# United States Patent and Trademark Office

APPLICATION NO.	FILING DATE	FIRST NAMED INVENTOR	ATTORNEY DOCKET NO.	CONFIRMATION NO.
09/965,973	09/28/2001	Mark A. Freeman		5182
7590 09/09/2005			EXAMINER	
Mark A. Freen	man		HYLTON, ROBIN ANNETTE	
8928 Twilight Lenexa, KS 66219			ART UNIT PAPER NUMBER	
Bollona, 185 - 00217			3727	
		DATE MAILED, 00/00/2005

#### **DETAILED ACTION**

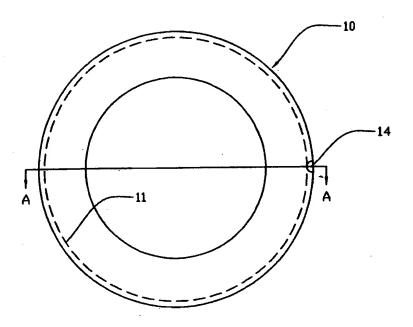
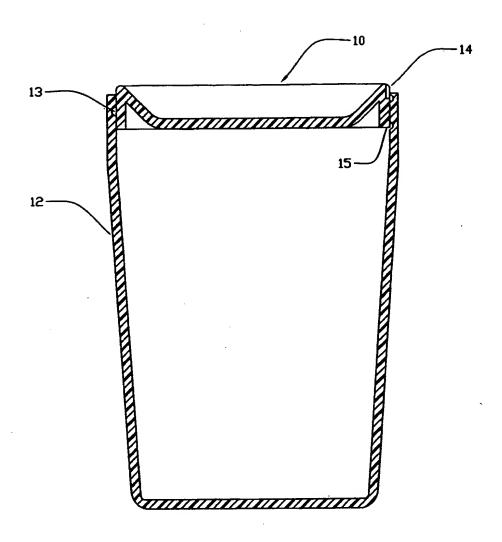
Replacement sheet containing Figures 1 and 1A is approved.
